Office Action Summary	Application No. 10/569,229	Applicant(s) ATAKE, HIROYUKI	
	Examiner AMJAD ABRAHAM	Art Unit 1791

DETAILED ACTION

2. Claims 1-6 are rejected under 35 U.S.C. 102(b) as being anticipated by Atake (USP No. 6,325,607).

FIG. 5

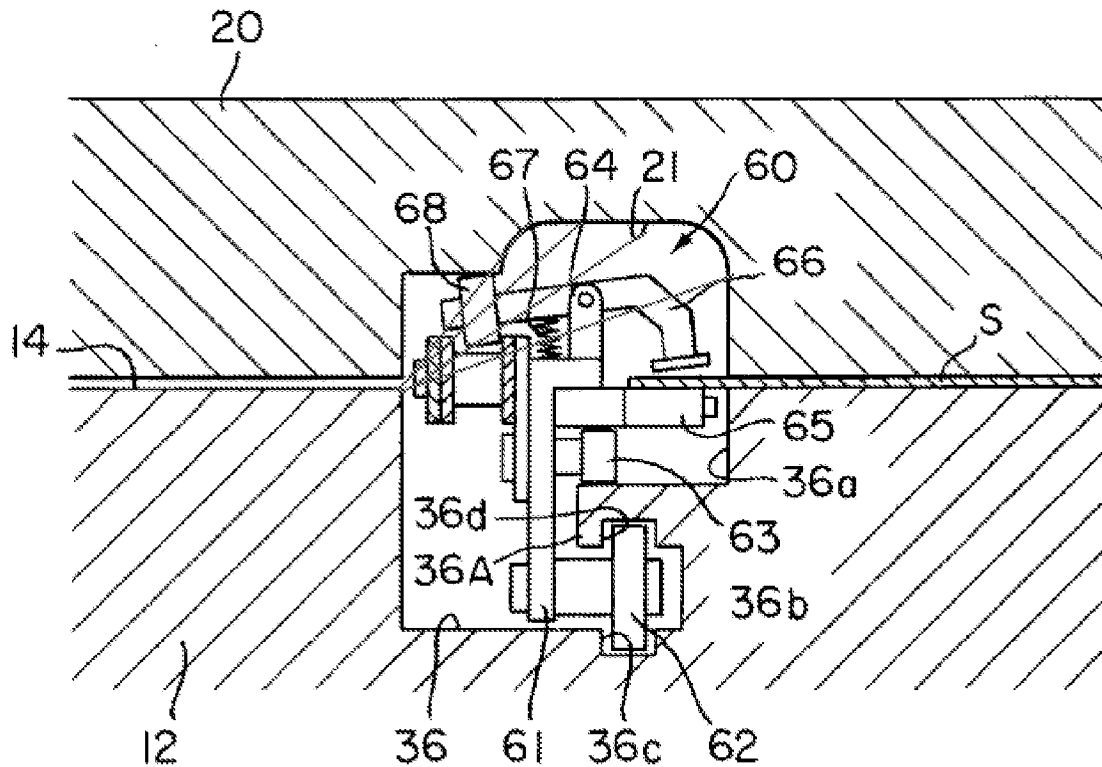
viii. Wherein the clamber is formed in such a way that when the pushing frame (rectangular portion of part 20) contacts the parting surface (14) of the female mold—there is a space between the connecting

member and the parting surface. **(See figures 4-5, column 7 lines 43-52, and column 12 lines 19-31).**

(10) See figure 5 depicted below--- The lines emanating from parts 21, 64, 66, and 67 to a common point on the parting surface of the female mold show the space between the connecting member and the parting surface.
